MPI Penalty for Optical PMDs

(Comments 342, 344, 346)

**IEEE 802.3dj Plenary Meeting
Madrid Spain**

July 28, 2025

DGD Penalty for Clauses 180-183

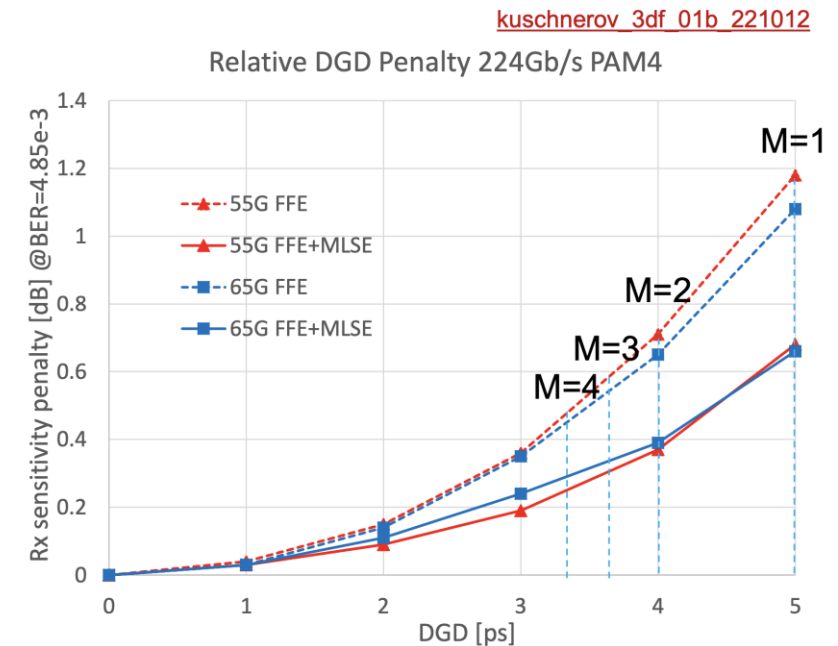
❑ [kuschnerov_3dj_optx_01_230829](#) show worst case DGD penalty of 0.7 dB for clause 183 800GBASE-LR4 PMD for max DGD of 4 ps

- 800GBASE-FR4 with max DGD of 2.3 ps has ~0.18 dB penalty
- 800GBASE-FR4/DRx-2 with max DGD of 2.3 ps has ~0.18 dB penalty
- 800GBASE-FR4-500/DRx with max DGD of 2.24 ps has ~0.18 dB penalty

❑ For PMDs listing combined DGD/MPI penalty the MPI value should be added to the above values of DGDs.
